UNITED STATES ENVIRONMENTAL PROTECTION AGENCY REGION III

SUBJECT:

Site 10 Phase II Aquifer Testing Report

Allegany Ballistics Laboratory, Rocket Center, West Virginia

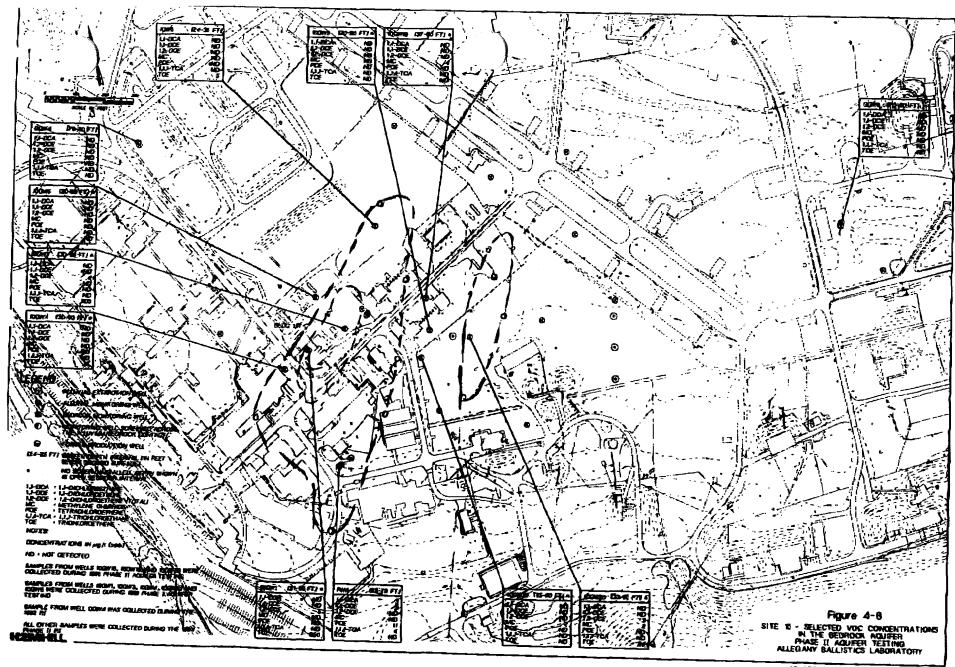
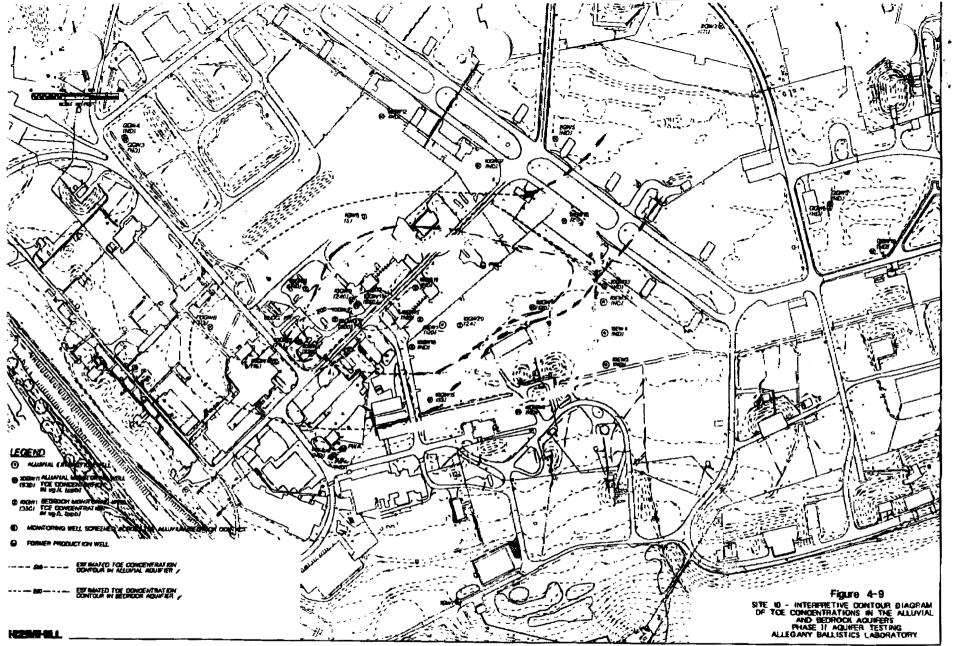
- 8. Figures 4-7 and 4-8: Please update figures to include outlines for VOC concentrations (see attached figures).
- 9. Figure 4-9: Please update this figure to represent the potential TCE contours in relation to the total VOC contours on the new figures 4-7 and 4-8 and that might reflect the piezometric surfaces shown on figure 4-3 and 4-4 (see attached figure).
